ROBINSON
HELICOPTER COMPANY

SERVICE LETTER #23A

Subject: Special Caution When Installing Vee Belts or Other Driveline Components

Rotorcraft Affected: All R22 Helicopters

Note 1.

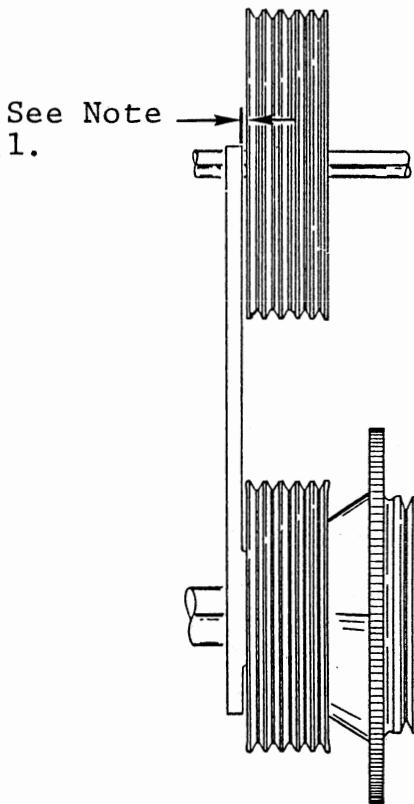
This gap will be .070" when sheaves are aligned and .000" when upper sheave is .070" aft of the lower sheave.

View from right side.

- a) The upper sheave must not be forward of lower sheave. It must be .000" to .070" aft of lower sheave.
- b) The difference between the left and right sheave alignment measurements must not be greater than .020". If measurements differ more than .020", adjust lateral clutch centering per Section 7.250 of the Maintenance Manual.

Sheave alignment bar position.

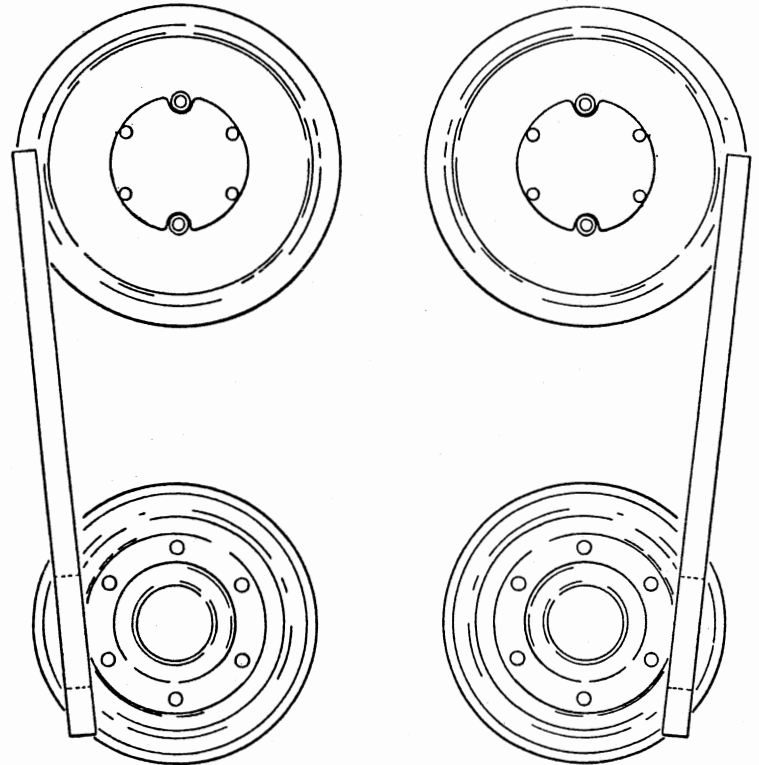
3. Engage clutch.
4. Using the MT331 Sheave Alignment Bar, check sheave alignment on left and right sides of upper and lower sheaves per Figure 2.

The upper clutch sheave must be aligned with the lower sheave within the following tolerances:
